EPC PACKAGE FOR LARA SUPER THERMAL POWER PROJECT, STAGE-II (2x800 MW)
Amendment No. 02 to Technical Specifications Section-VI of Bidding Document No.: CS-9587-001R-2

Doc. No.: CS-9587-001R-2-TECH AMDT- 02	LARA SUPER THERMAL POWER PROJECT STAGE-II (2X800 MW)	Amendment No. 02 to Technical Specifications Section-VI
---	---	--

Annexure H

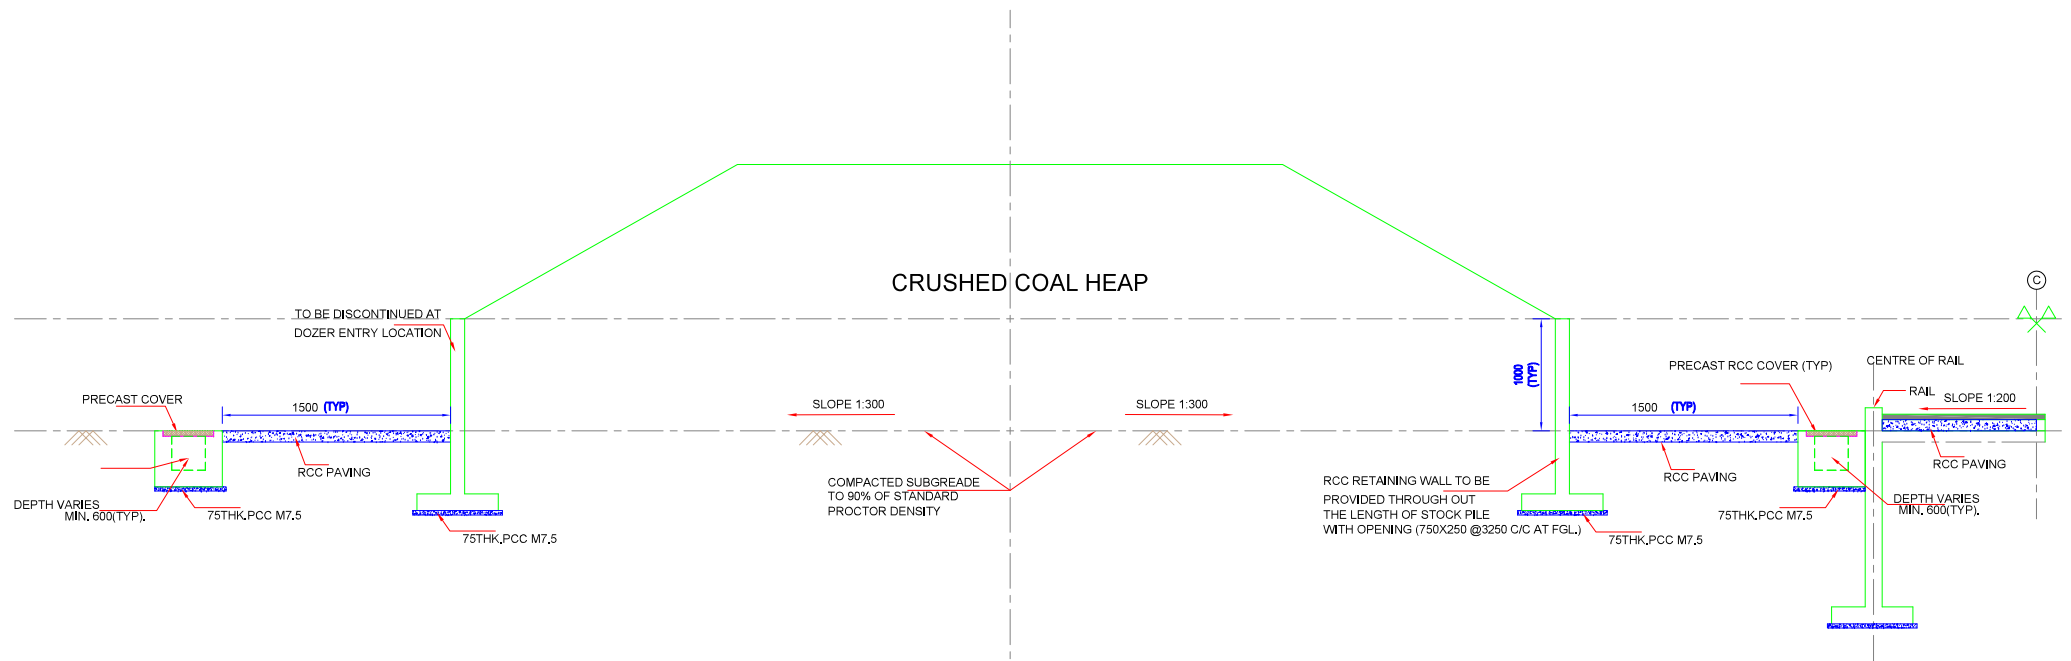
D2-14	VI/B	D-1-9	9.17.00 TABLE A&B	19 TO 30	Table A and B	Table A and B revised and attached as Annexure D2-C
D2-15	VI/B		ANNEXURE H		Indicative arrangement of Coal Stock Pile	Indicative arrangement of Coal Stock Pile revised and attached as Annexure D2-D
D2-16	VI/E				9587-999-POC-F-001-Rev-0	9587-999-POC-F-001-Rev-A
